Access Compliance Report Public Rights-of-Way (Curb Ramps)

Main Street: SIENNA_PKWY Cross Street: ETHEREAL_RD Location: E

ADA ID: RPRK211104122412 Ramp Type: Type 1 - Perpendicular Initial Pass/Fail: Fail Overall Compliance: No Severity Score: 2

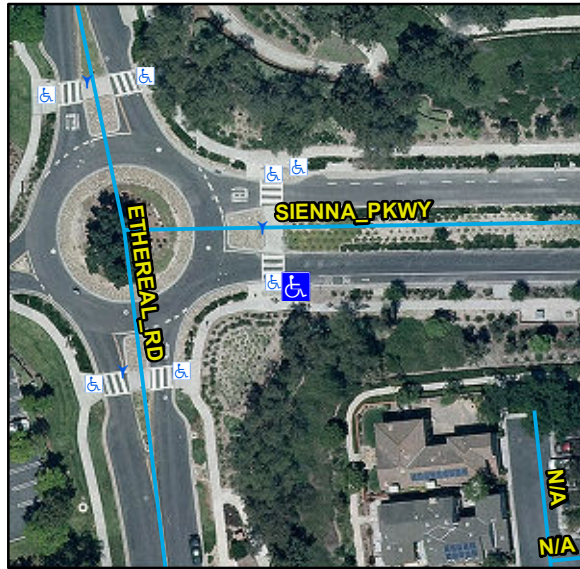
R304.2.2, R204.3, R304.5.3, STD 1115

Remove & Replace Entire Ramp.
